UNITED STATES PATENT AND TRADEMARK OFFICE

Office Action Summary	Application No. 10/517,787	Applicant(s) PEDRETTI, MAURO	
	Examiner MICHAEL P. FERGUSON	Art Unit 3679

DETAILED ACTION

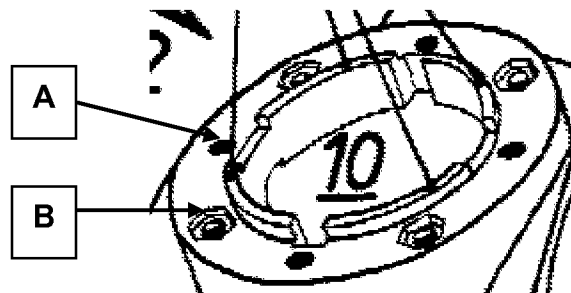
As to claim 1, as best understood, Fenner discloses a joint element **11,40** capable of introducing tensile and compressive forces, in a manner free of bending moments, into pneumatic structural elements which comprise a sleeve **1**, at least one compression member, at least two tension members and two spherical caps **3,4**, the joint element comprising:

means **A,B** capable of fastening tension members and a compression member (Figure 1 reprinted below with annotations), wherein the joint element is capable of functioning such that:

vectors of forces of the at least two tension members, of at least one compression member and of bearing forces in the joint element added together are equal zero,

no torques are introduced from the outside or diverted to the outside elements, bending moments within the joint element occur symmetrically in relation to at least one compression member (Figures 1,2,8).

As to claim 2, as best understood, Fenner discloses a joint element comprising a plate **11,40** and having a large opening capable of receiving a spherical cap (Figure 1).

As to claim 3, as best understood, Fenner discloses a joint element wherein the plate **11,40** is round (Figure 1).

As to claim 4, as best understood, Fenner discloses a joint element wherein the plate **40** polygonal (plate **40** comprises polygonal portions; Figure 1).
